**Irish Water & Wicklow County Council**  
**Arklow Wastewater Treatment Plant**  
**Phase 1 Consultation Report**  
**Project No. PH 00 85700**  
**January 2015**

Document: Phase 1 Consultation Report

Project: Arklow Wastewater Treatment Plant

## Appendix A – Phase 1 Report Land Parcels

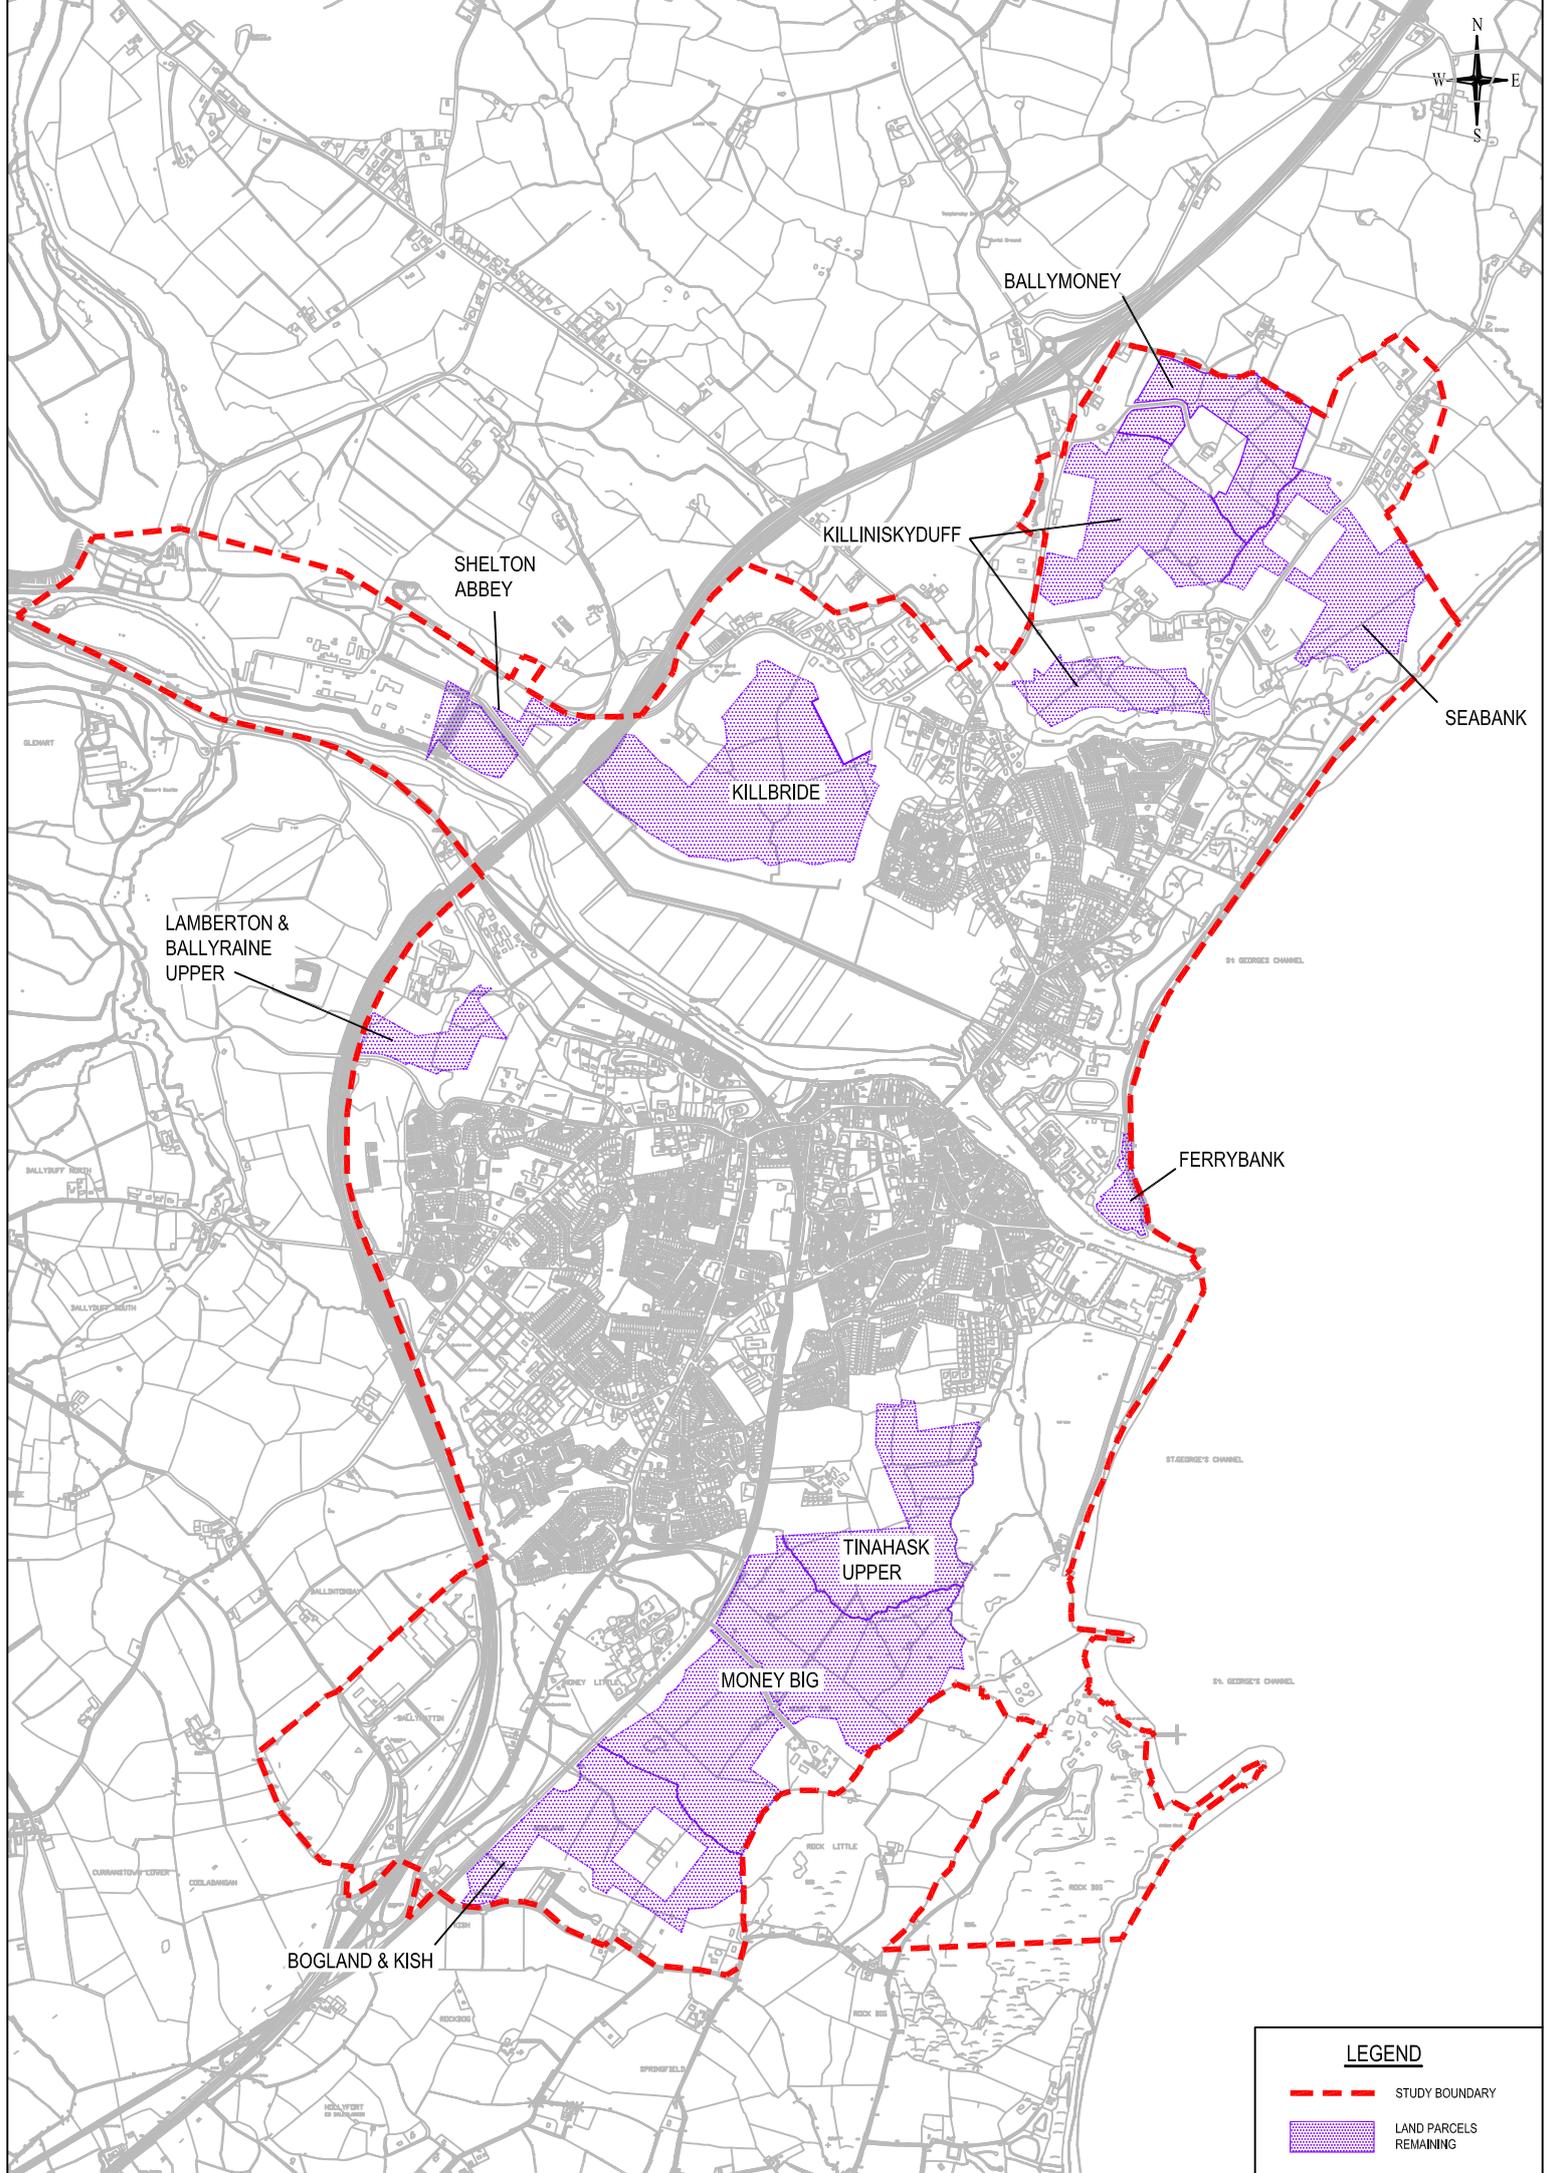
Note: The locations of the land parcels are included in Appendix A.

As the submissions received mentioned more than the three shortlisted land parcels, this report outlines all queries, questions, comments and observations raised on all of the land parcels that were mentioned by stakeholders during the consultation period. These comments are listed below on a land parcel basis. No comments, questions or queries were submitted by stakeholders on the following 3 no. land parcels – Ballymoney, Killbride and Money Big. The points raised are detailed below and are taken directly from the submissions received either as direct quotes or as summary points from a number of submissions.
